### DRAWING AMENDMENTS

### REMARKS

Applicant has carefully reviewed the Official Action dated October 6, 2005 for the above identified patent application.

# Marked Drawing Showing Revisions

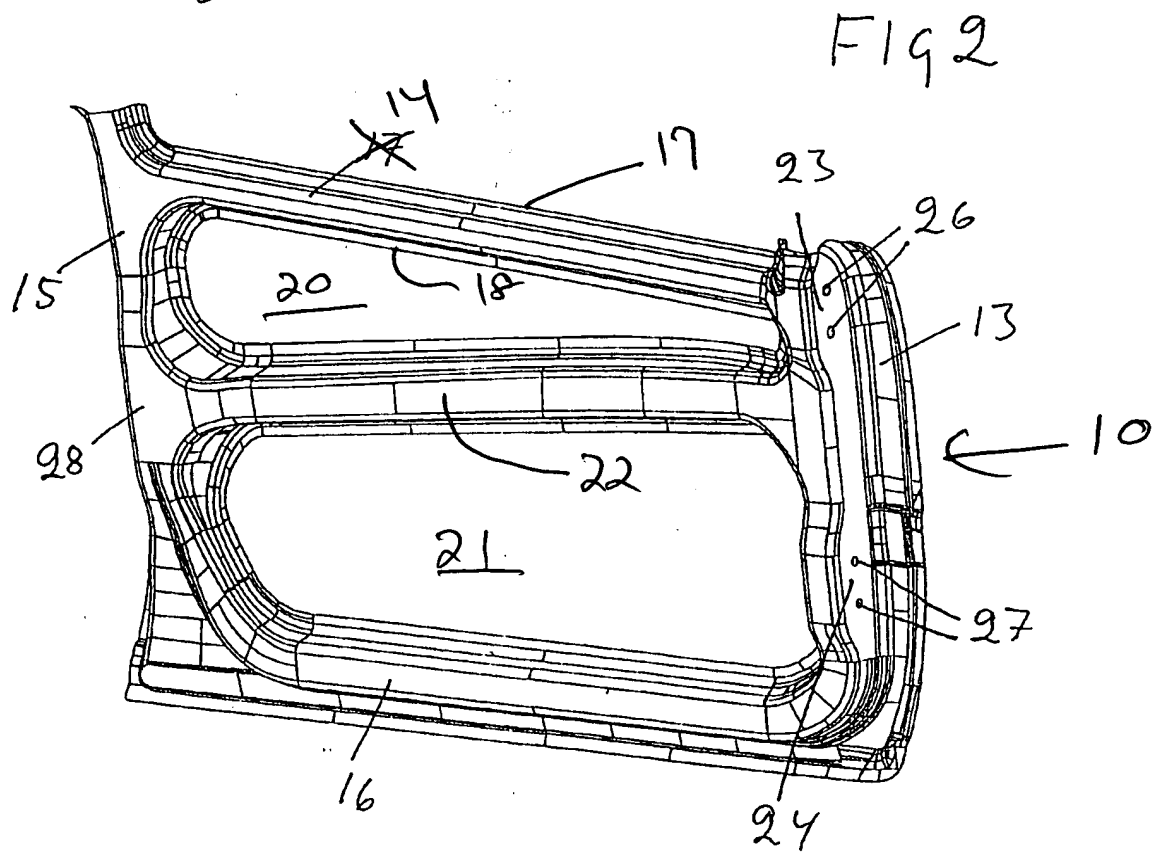
Enclosed are replacement sheets for FIGURES 1 - 2 and FIGURES 5 - 6 of the drawings. Also enclosed are copies of the original drawings marked to show the revisions.

Applicant has revised some of the reference numerals identified at page 2, penultimate paragraph of the specification which discusses Figures 1 and 2 of the drawings, to conform to the reference numerals in the drawings. Additionally, some of the reference numerals in Figures 1 and 2 of the drawings have been revised to conform to the reference numerals used in the penultimate paragraph of page 2 of the Specification. Applicant respectfully submits that the reference numerals designated in the discussion of Figures 1 and 2 of the Specification (as amended herein) conforms to the reference numerals designated in Figures 1 and 2 of the drawings (as amended herein).

# Marked Drawing Showing Revisions

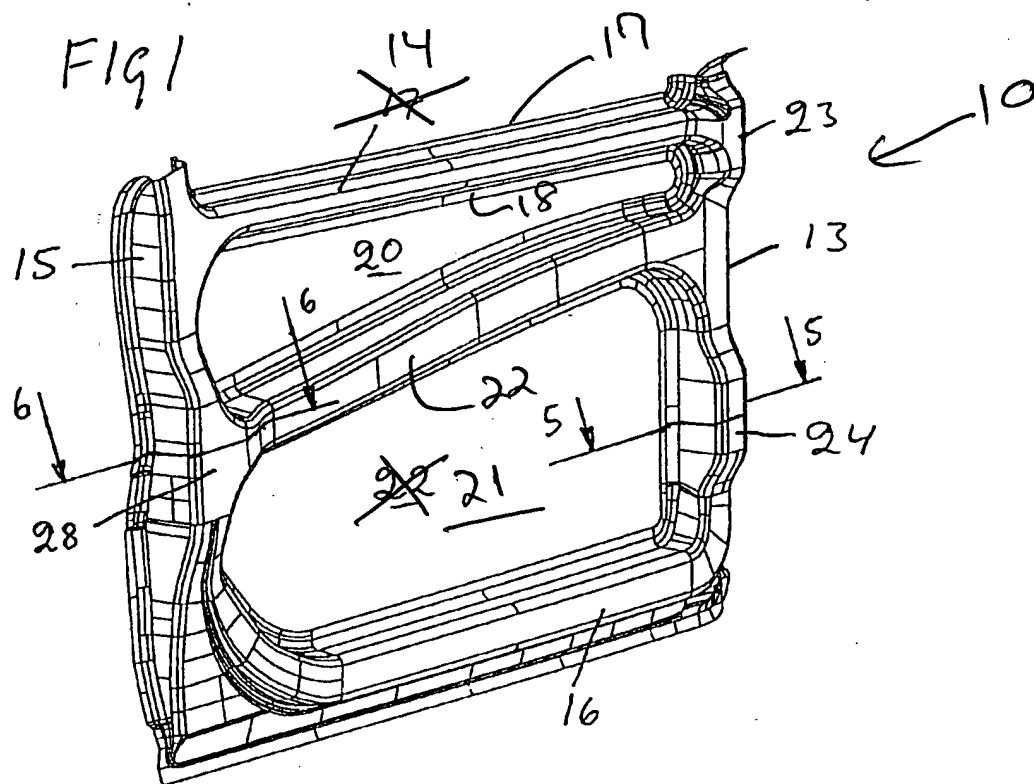
Applicant has also replaced reference numeral 28, which refers to the "outer panel" at the next to the last line of the last paragraph of page 2 of the Specification, with reference numeral 29. Additionally reference numeral 28 has been replaced with the reference numeral 29 in Figures 5 and 6 of the drawing to conform to the revision to the Specification. The reason for this change is that reference numeral 28 has already been used in the Specification and drawing to designate the region at which the rear end of the impact guard beam 22 joins the rear standing

hat beam 15 (See Figures 1 and 2 of the drawing and page 3, second full paragraph of the Specification).
